**FINDINGS AND RECOMMENDATION
OFFICE OF PLANNING AND ZONING
ANNE ARUNDEL COUNTY, MARYLAND**

APPLICANT: Effect, Inc.

CASE NUMBER: 2023-0193-V

HEARING DATE: February 27, 2024

VARIANCE PLAN
EFFECT INC. PROPERTY
 10000 Bay Road, Suite 100
 Houston, TX 77055
 (281) 415-1000
 www.bayengineering.com

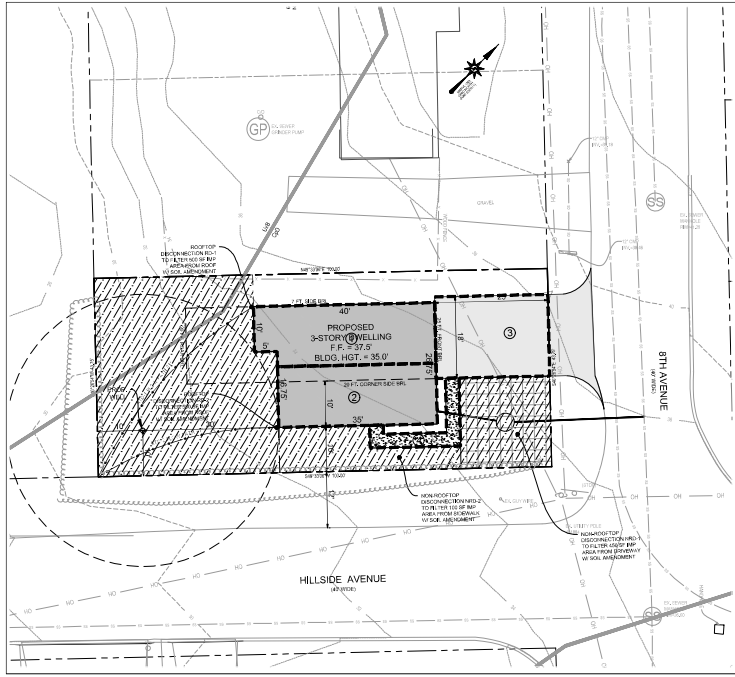
§ 18-4-701 of the Anne Arundel County Zoning Code provides that a principal structure in an R5 District shall be set back a minimum of 20 feet from a corner side lot line. The proposed dwelling would be constructed ten feet from the corner side lot line, necessitating a variance of ten feet.

The **Health Department** recommends denial of the requested variance because the site plan is not approvable. The proposed well does not meet the required setbacks to the right-of-way or to the existing sewer main.

The Health Department recommends denial of the above referenced request based on the site plan not being approvable. The proposed well does not meet the required setbacks to the right -of-way or the existing sewer main.

While it is clear that some zoning setback relief is warranted, the variance is not considered to be the minimum necessary to afford relief and to allow the lot to be developed with a dwelling. The proposed house size is deemed to be excessive for the small site. The applicant should consider alternative design options to minimize the visual impacts of the requested corner side setback variance, by narrowing the dwelling footprint and by reducing the proposed height/stories.
